SP2022-035

PROJECT NUMBER: SP2022-035  
PROJECT NAME: Site Plan for Harbor Residences  
SITE ADDRESS/LOCATIONS:

CASE CAPTION: Discuss and consider a request by Asher Hamilton of RIV Properties, LLC for the approval of a Site Plan for a 176-unit condominium building on a 3.59-acre tract of land identified as Lots 1, 2, 3, & 4, Block 2; Lots 1, 2, 3, & 4, Block 3; Lots 1, 2, 3, & 4, Block 5; Lots 1 & 2 and a portion of Lots 3 & 4, Block 6; Lots 2, 3, & 4, Block 7; Lots 1 & 2, Block 8; and Lots 1, 2, 3, & 4, Block 9, Moton Addition, City of Rockwall, Rockwall County, Texas, situated within the Hillside Mixed Use Subdistrict and the Horizon/Summer Lee Subdistrict of Planned Development District 32 (PD-32), generally located at the southwest corner of the intersection of Horizon Road and Summer Lee Drive, and take any action necessary.

DEPARTMENT	REVIEWER	DATE OF REVIEW	STATUS OF PROJECT
PLANNING	Henry Lee	06/24/2022	Needs Review

SHEET NUMBER AND TITLE:  
2.1 SITE PLAN

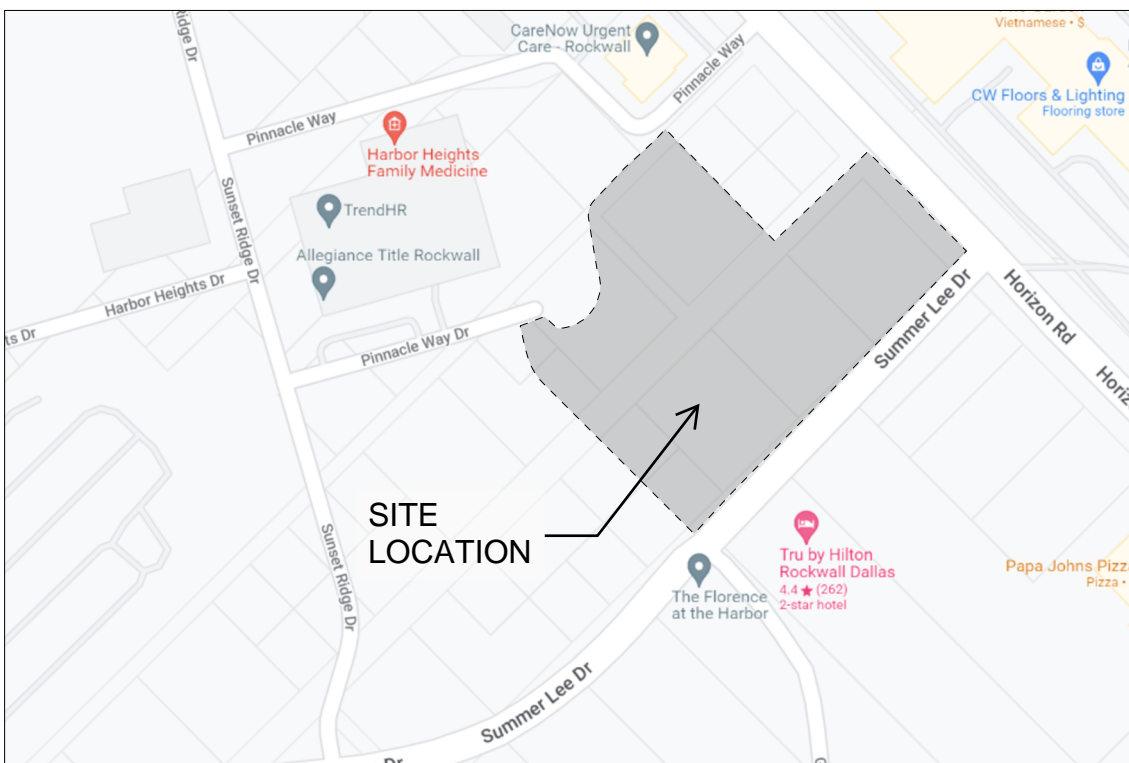
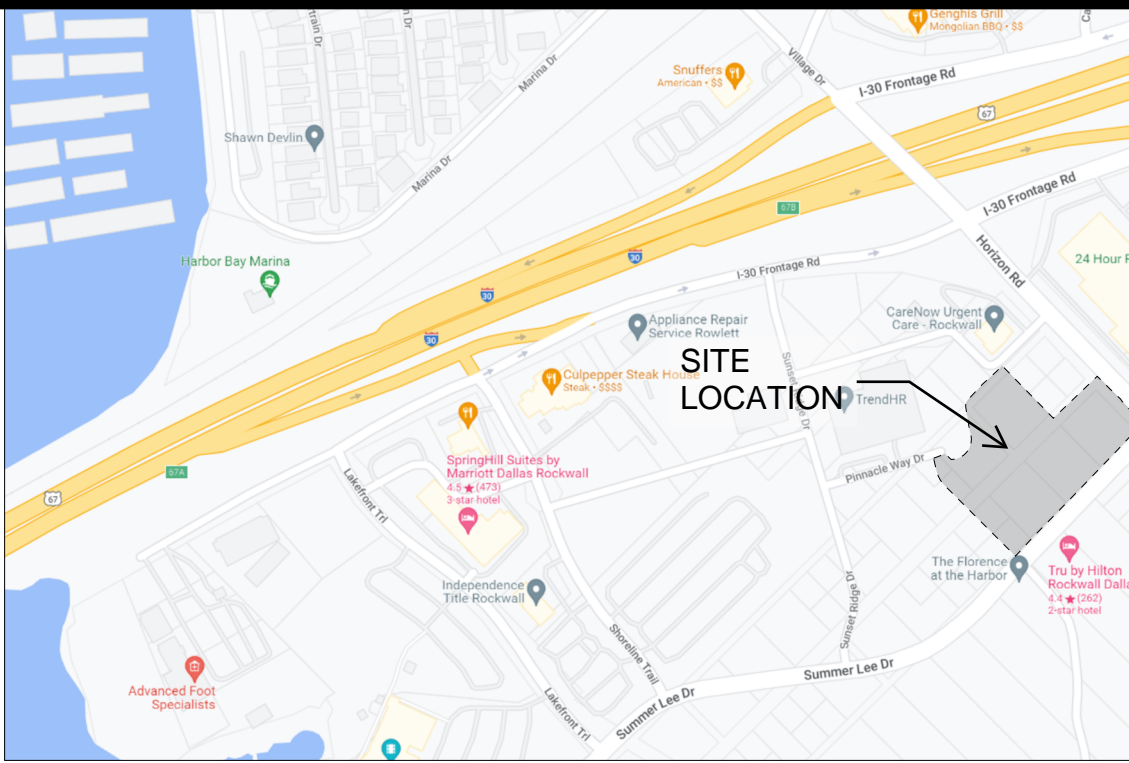
M.9 Site Plan:

1. Provide a numeric and graphic scale. (Subsection 03.04. A, of Article 11)
2. Please include the lot square footage. (Subsection 03.04. B, of Article 11)

7. Please indicate all building setbacks adjacent to public ROW. The building setbacks were changed as part of the PD Development Plan from the previously approved case (Case No. Z2022-001), so use these setbacks. (Subsection 03.04. B, of Article 11)

10. Please indicate all adjacent streets ROW. (Subsection 03.04. B, of Article 11)
11. Please only provide the parking table on the site plan. (Subsection 03.04. B, of Article 11)

12. Please indicate the type and height of all proposed fencing. (Subsection 03.04. B, of Article 11)
13. If there is any ground mounted equipment it must indicated on the site plan with the subsequent screening. (Subsection 01.05. C, of Article 05)

SHEET NUMBER AND TITLE:  
6.1 BUILDING ELEVATIONS

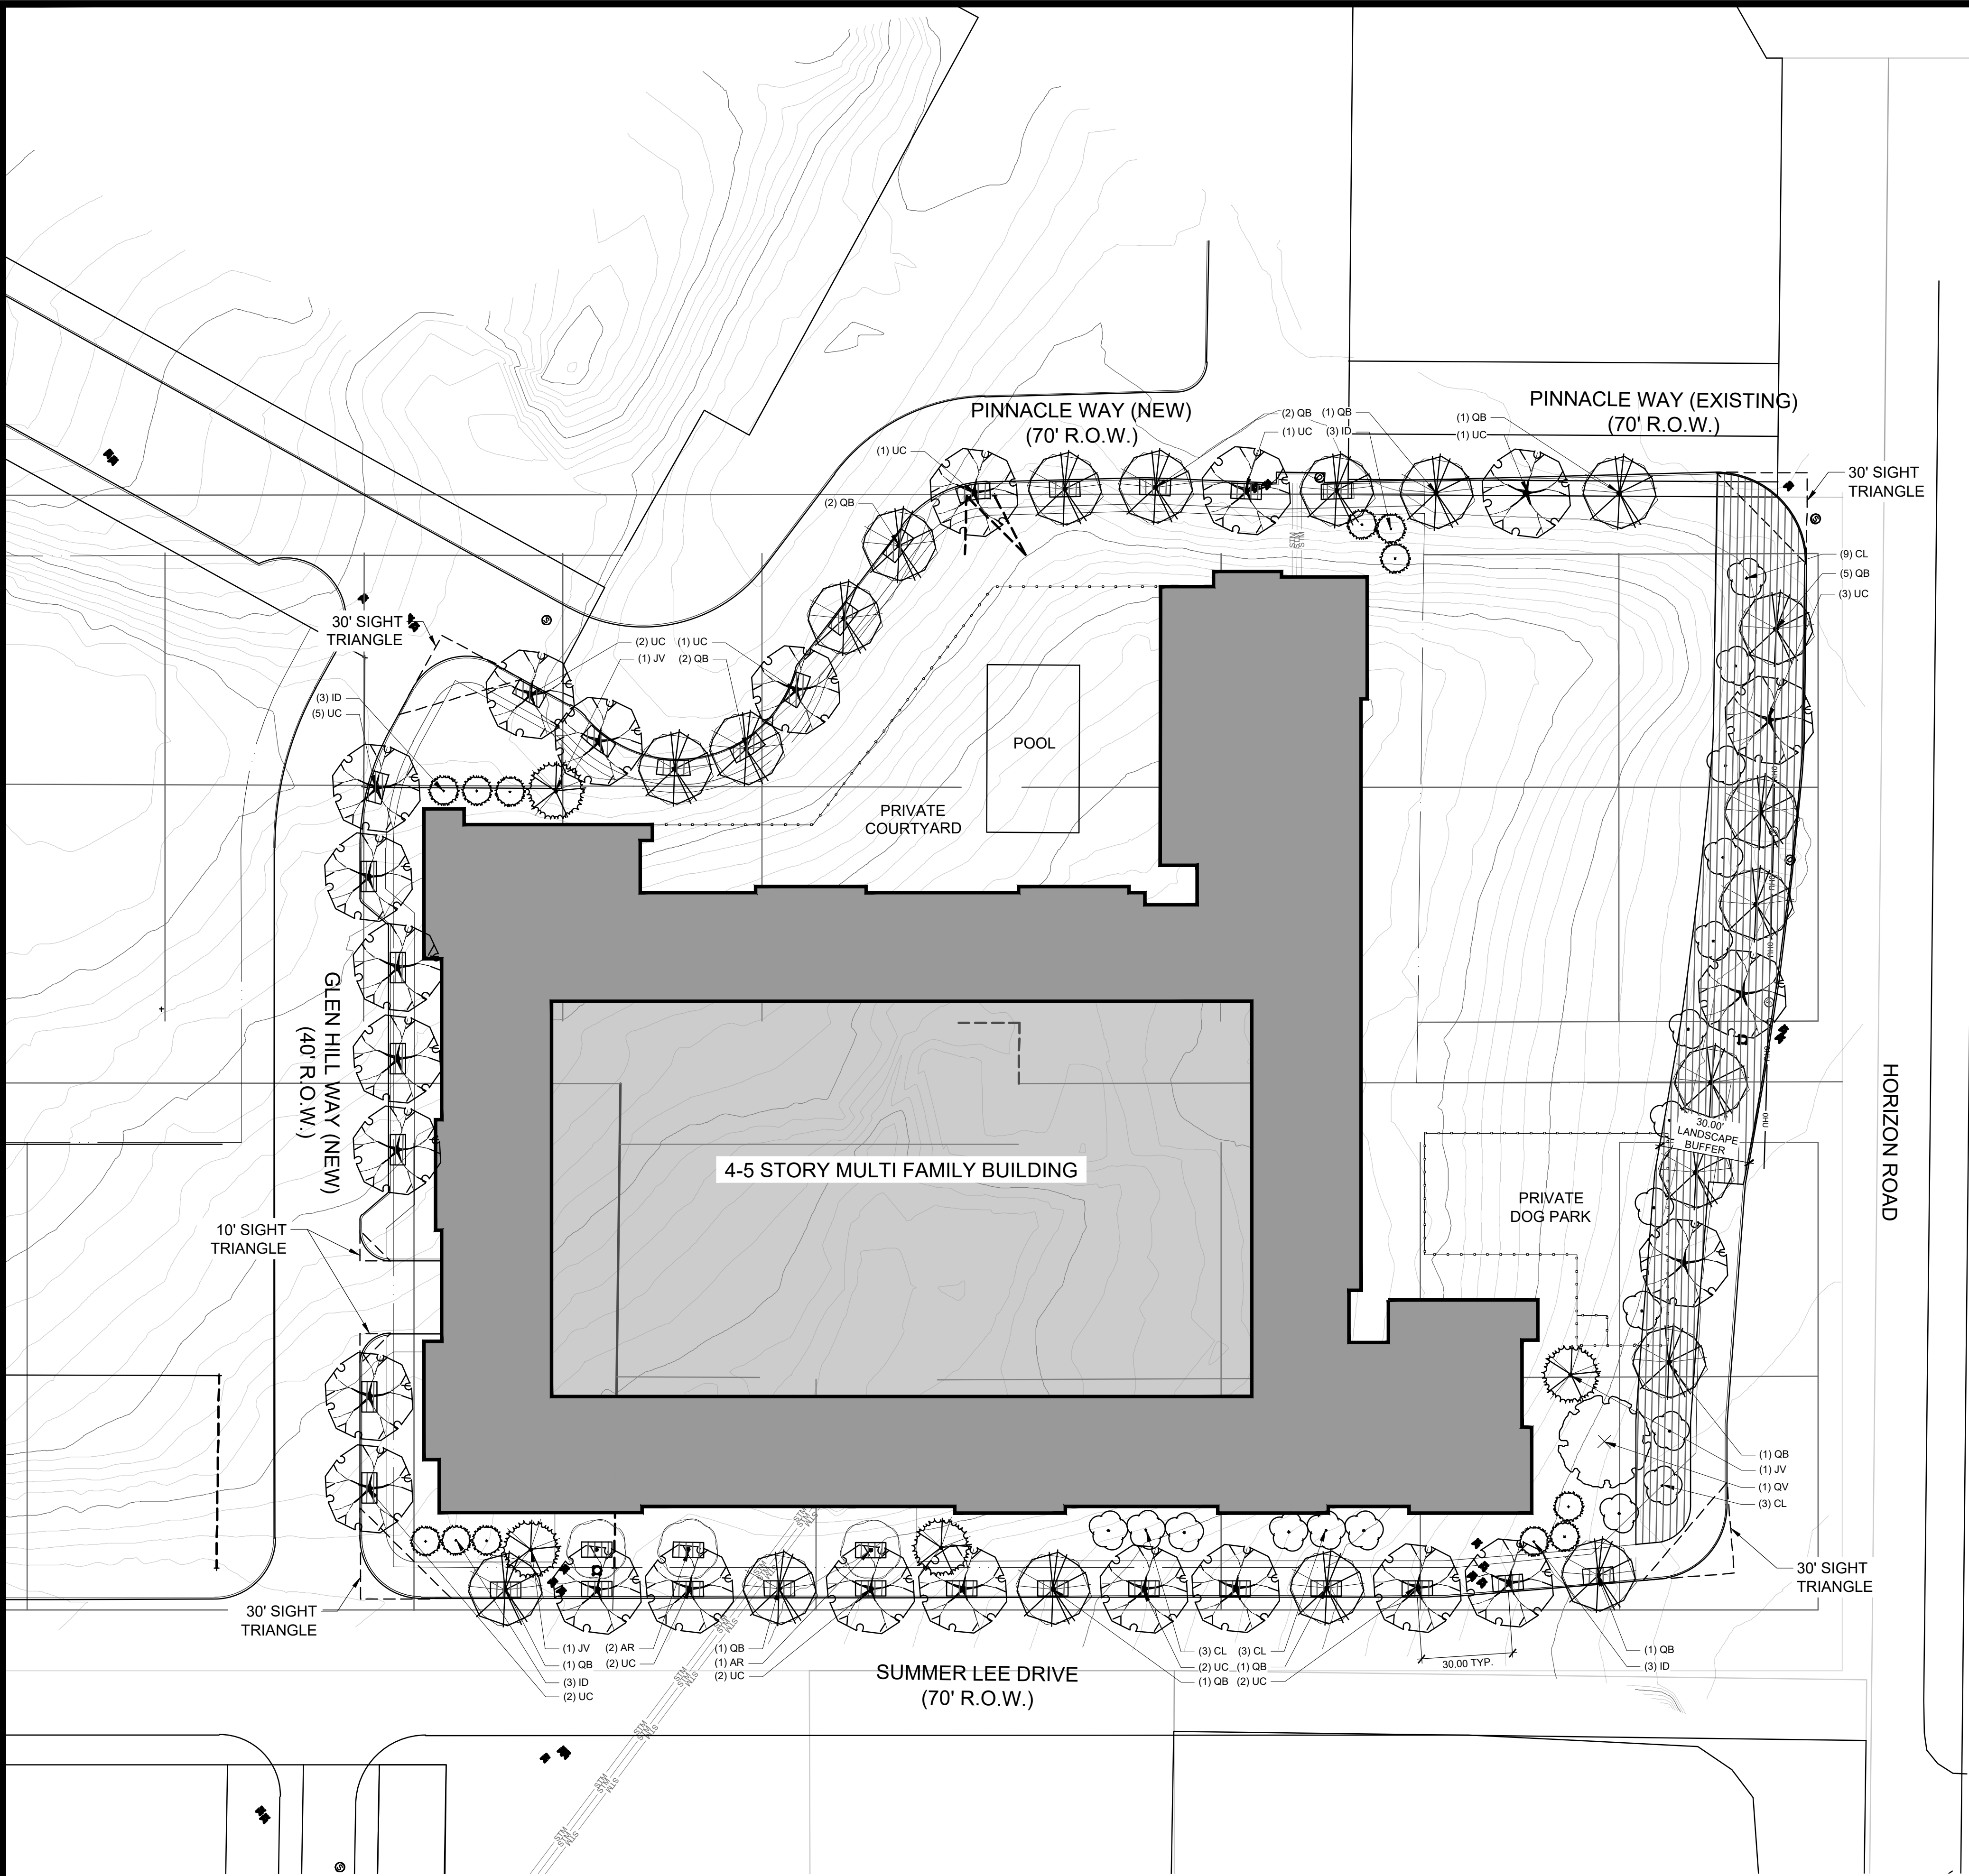
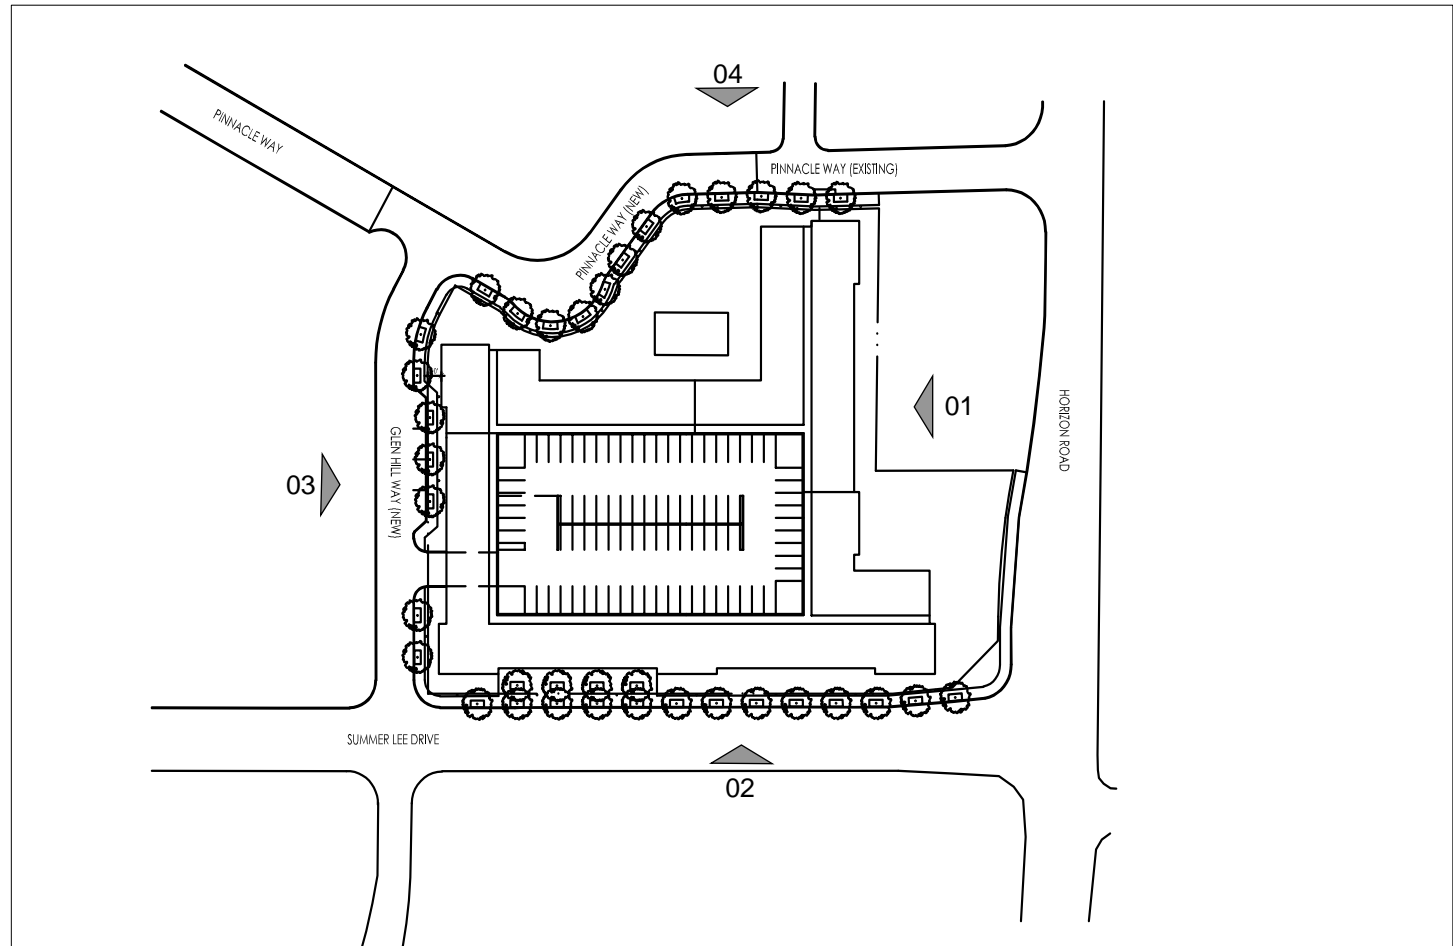
1. Please remove all of the signage from the building elevations. (Subsection 06.02. F, of Article 05)
2. Please indicate where the dumpster enclosure is on the elevations. (Subsection 01.05. B, of Article 05)

3. Please provide callouts for the materials on the building. (Subsection 04.04, of Article 05)
4. 20% natural or quarried stone is required on each façade of the proposed building. (Subsection 06.02. C, of Article 05)

SHEET NUMBER AND TITLE:  
3.1 LANDSCAPE  
PLAN

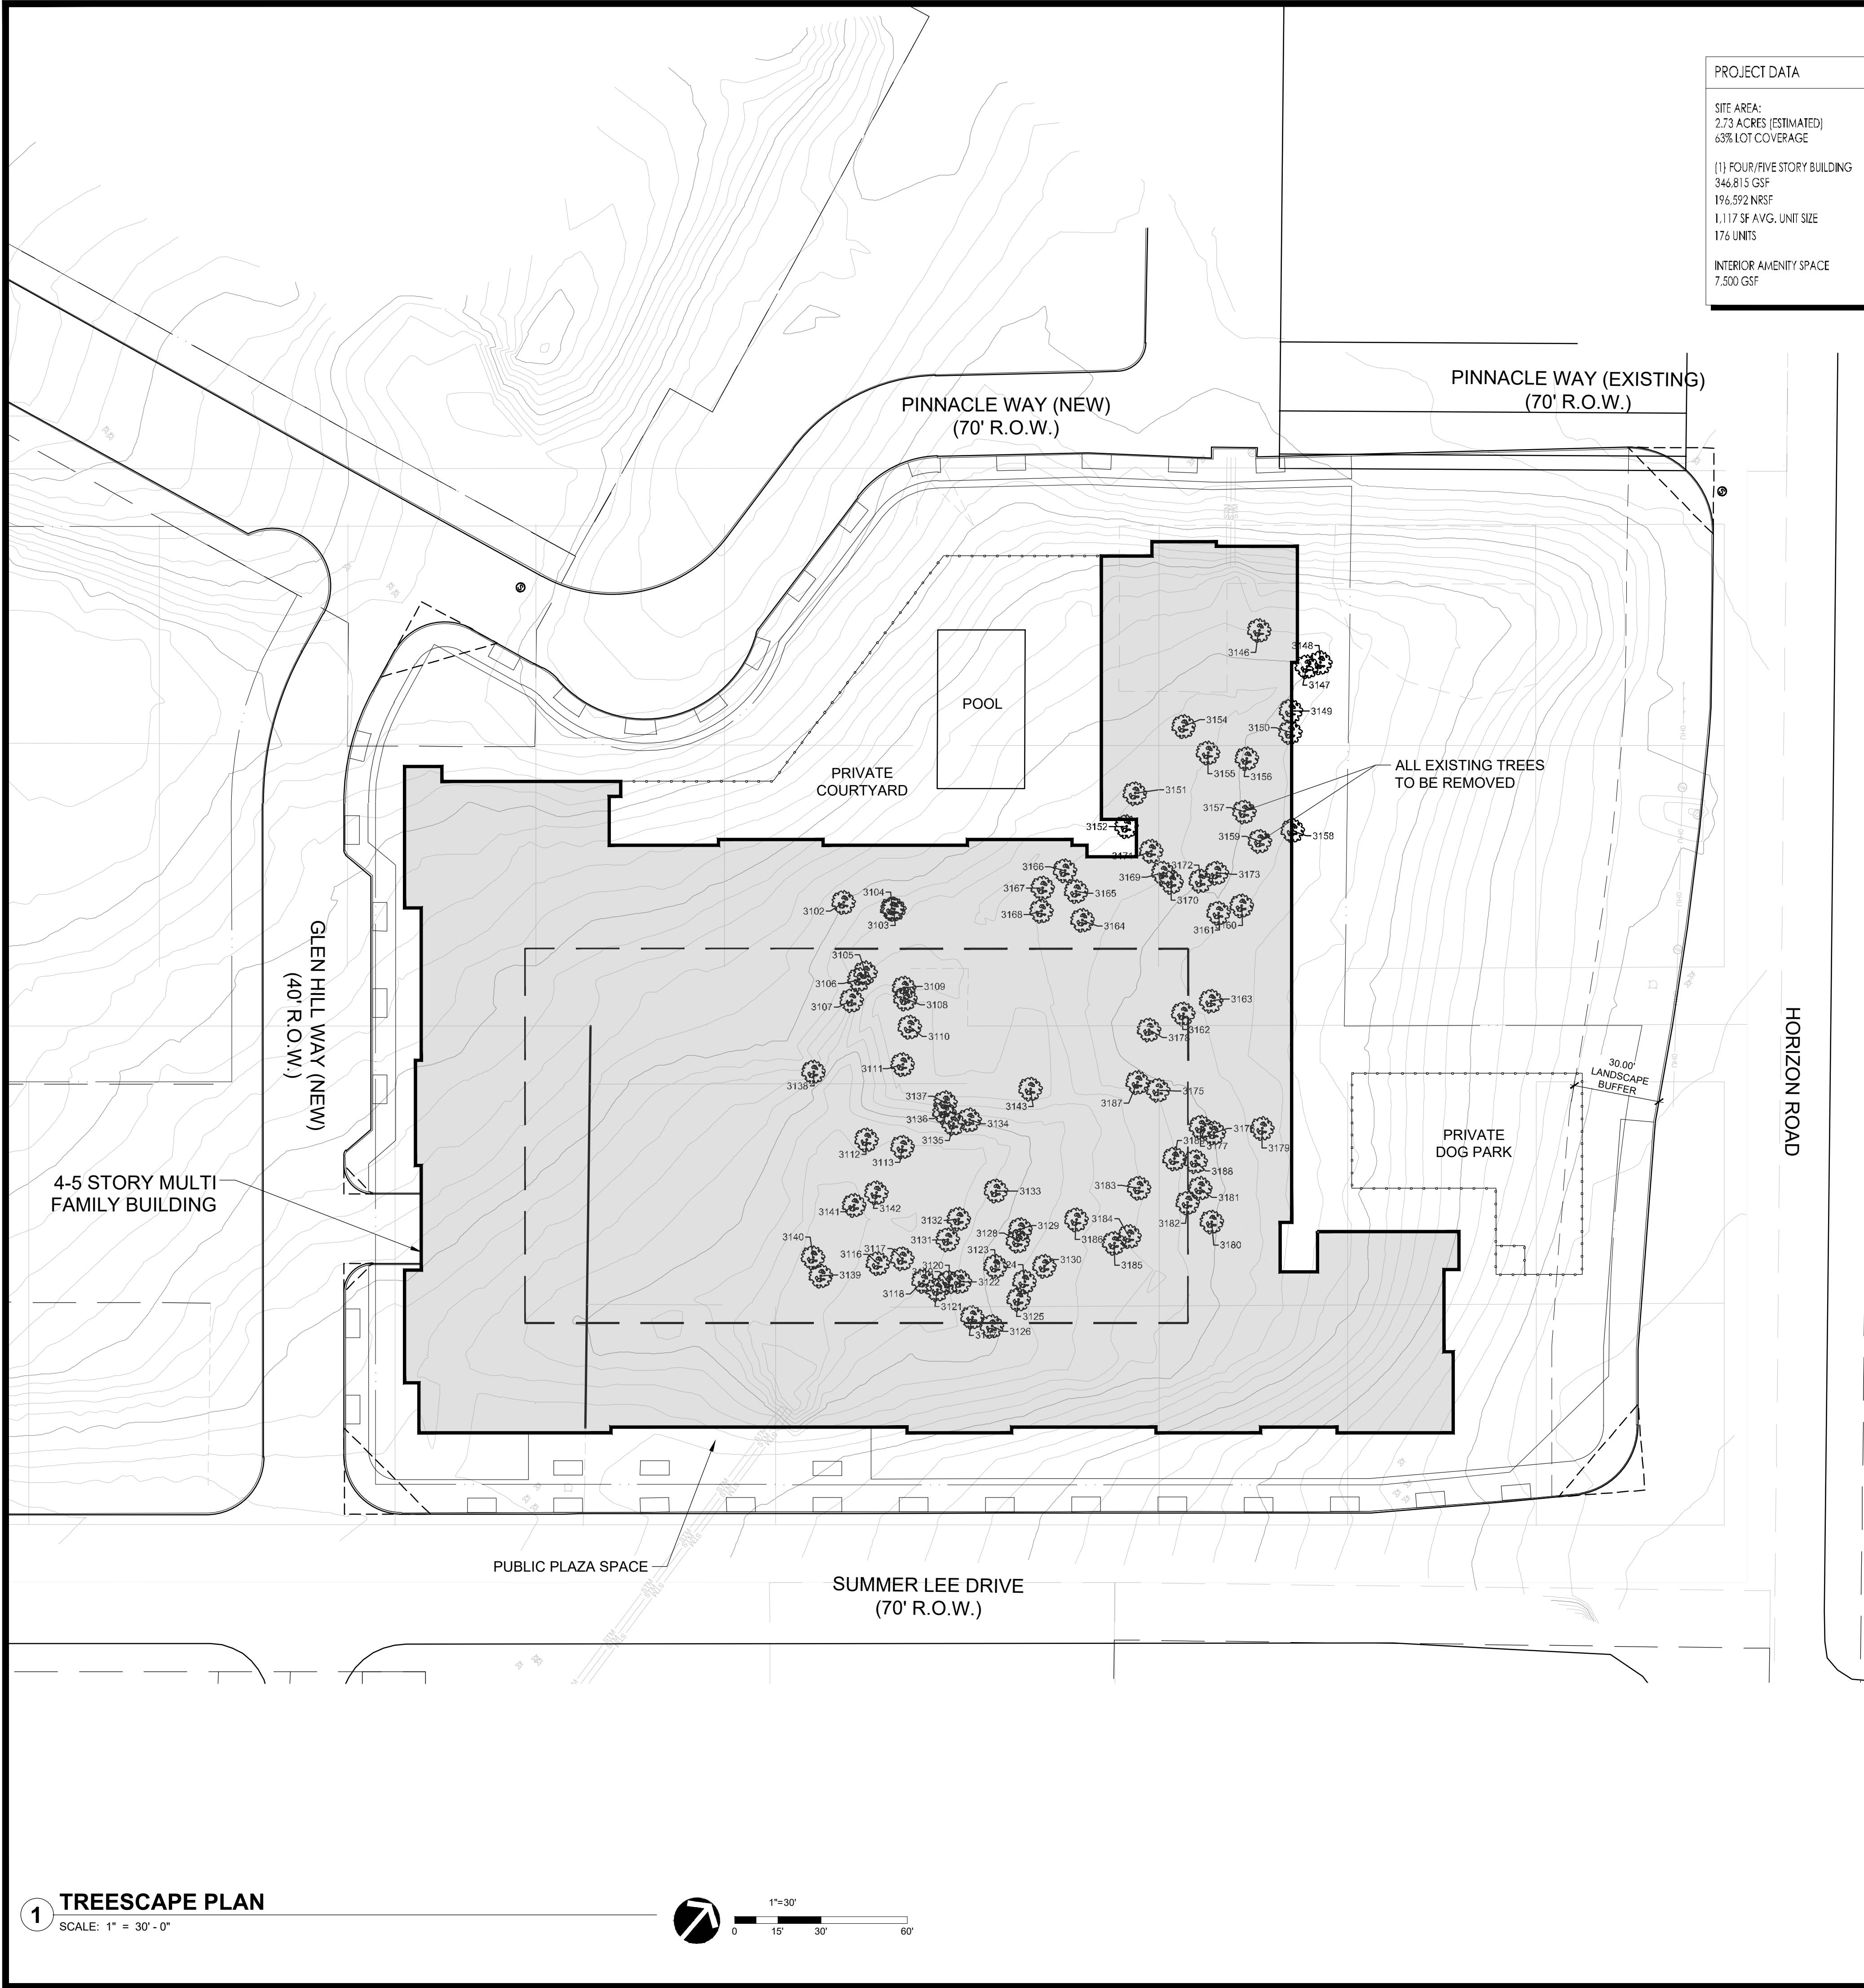
M.10 Landscape Plan:

1. Provide the same site data as the site plan site data table. (See Sec. 2.1 of this checklist)
2. Provide the impervious vs. landscaped area within the site data table. Verify the impervious area as the building is included in that calculation. (Subsection 01.01. B, of Article 05)
3. All shrubs shall be 5-gallon (Subsection 05.03. B, of Article 08)
4. Provide more detail on the "shrub area;" include the species and location of the planting. (Subsection 05.03, of Article 08)
5. The October Glory Red Maple, Possumhaw Holly, and Eastern Red Cedar are not approved trees for PD-32. PD-32 includes a master planting list that you should consult it. (Ordinance No. 17-22)
